Device TC22x/TC21x
Marking/Step ES-AC, AC
Package see Data Sheet

10208AERRA

This Errata Sheet describes the deviations from the current user documentation.

Figure 1 Example sequence showing how registers ETRRx may be filled with “Error Free” addresses

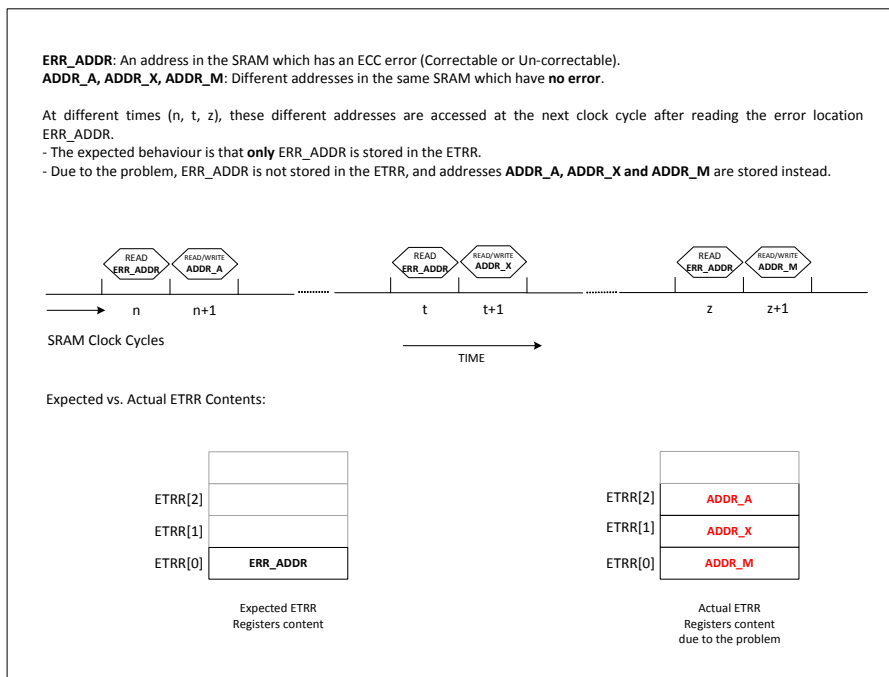
are filled with addresses that have actually no error – and the SRAM address which actually has an error is not stored indeed. **Figure 1** shows such an example scenario.

The consequence of the scenario explained in **Figure 1** is that a single error in the SRAM – example just one correctable error at a location ERR_ADDR – can result in registers ETRRx getting filled with fault-free address, and thus potentially even triggering an ETRR overflow.

2. Depending on the access sequences, an ETRR overflow might be triggered with one real error (e.g. correctable error) in the SRAM – consequence of the example shown in [Figure 1](#).

Figure 2 Recommended Software Handling - Flowchart

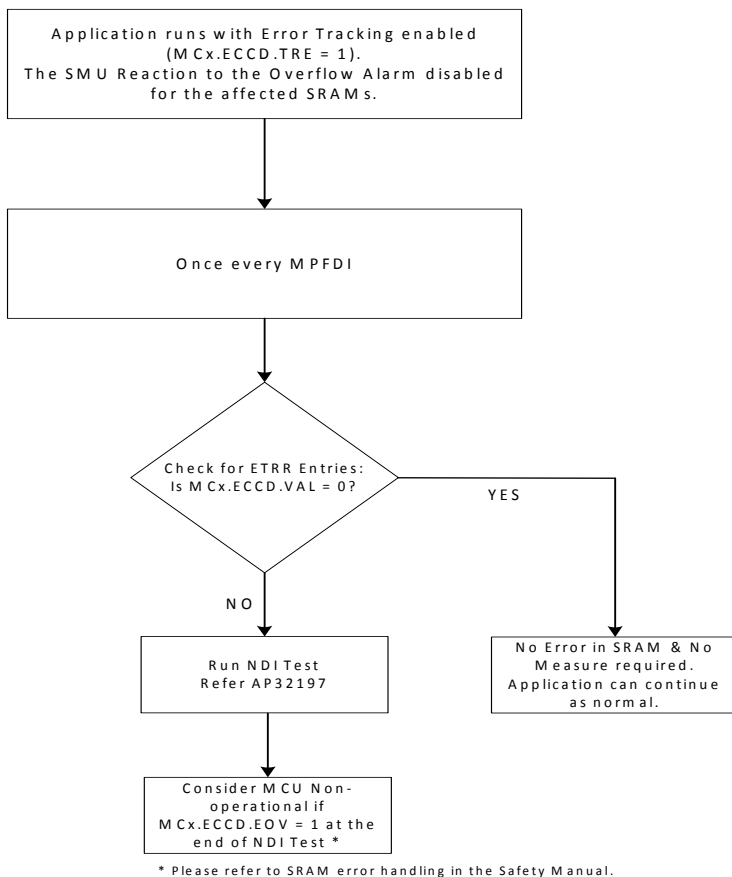
A flowchart of the recommended software handling is shown in [Figure 2](#).

If there is at least one valid ETRR entry (i.e. $MCx.ECCD.VAL \neq 0$) then the software shall run a Non-Destructive-Inversion (NDI) Test on the affected SRAM. Please refer to application note AP32197 (AURIX™ Memory tests using the MTU) for an example regarding running this test.

At the end of this test, if an ETRR overflow is detected ($MCx.ECCD.EOV = 1_B$) then the MCU shall be considered non-operational. Refer to section on Correctable SRAM Error handling in the Safety Manual.

Figure 8 Ripple Voltage vs. Frequency Characteristic

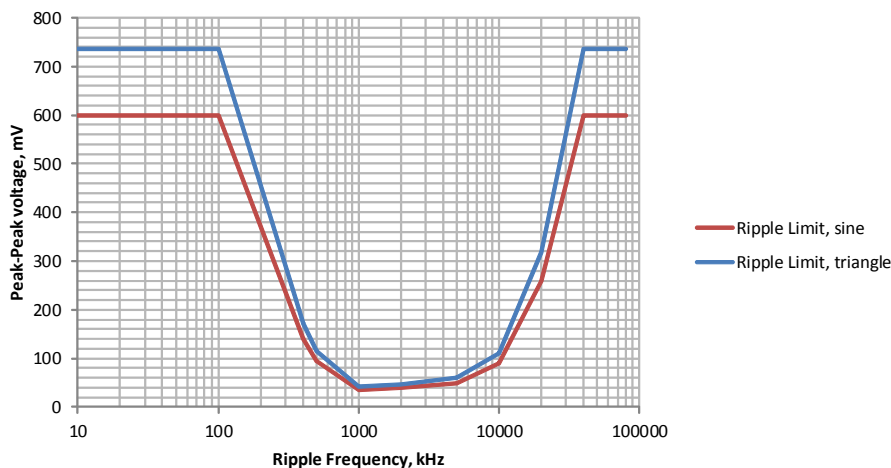
improper behavior of the start-up scheme of the back-up clock, and thus stuck-at state during the start-up of the microcontroller until this condition is removed.

The diagram reflects acceptable ripple level during the cold start of the microcontroller at the respective VDDP3/VEXT/VEVRSB supply of the PMS subsystem, depending on the device and package type, as shown in the following table.

Apply an additional ceramic capacitor at the respective VDDP3/VEXT/VEVRSB supply input (at pins specified above) to attenuate the residual ripple of the buck converter. The resonant frequency of the additional filter capacitor shall be chosen in accordance with the amplitude-frequency characteristic given above and the switching frequency of the DC-DC converter in order to provide a proper attenuation in the range of interest.

Figure 9 Short Serial Message, Serial Data Encoding over 16 messages

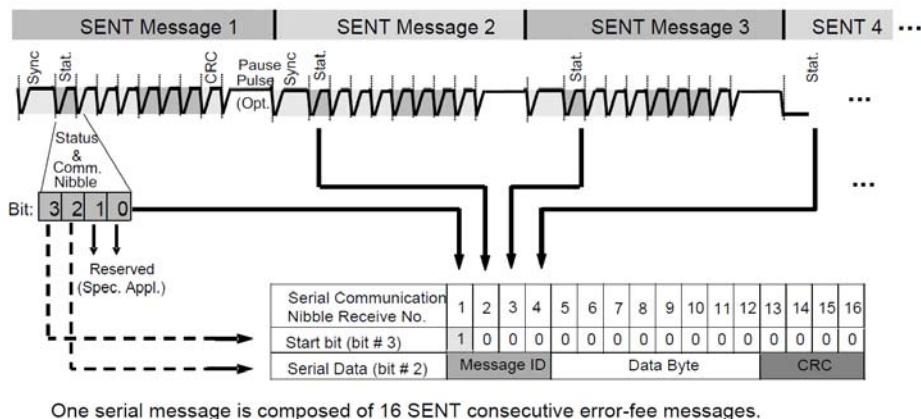
Figure 9 shows a corrected version of this figure.
